BART WARM SPRINGS EXTENSION

Final Environmental Impact Report

Comments, Responses and Revisions
to the Draft Environmental Impact Report

Prepared for
San Francisco Bay Area Rapid Transit

SAGS

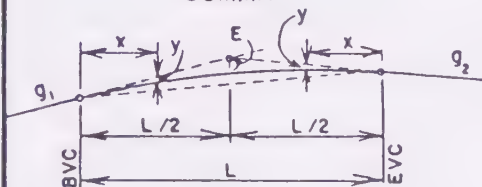
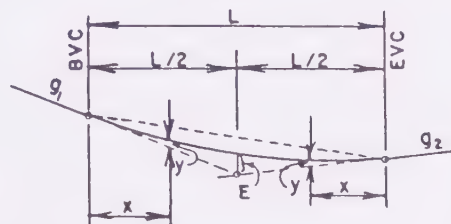
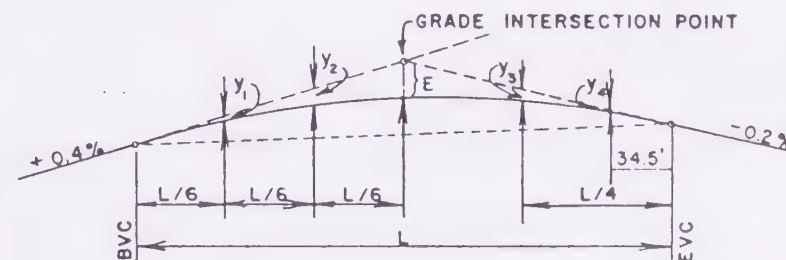
Comment PD-23 (SPTCo): Sheet 3, Drawing 3D, Proposed Project - 800' VC is too short; must be at least 1230'. Need alignment details for SPTCo track relocation (degree of curve, spiral length, superelevation, etc.)

Sheet 12, Drawing 4, Alternative 4 - 500' VC is too short; must be at least 795'. Need alignment details for SPTCo track relocation.
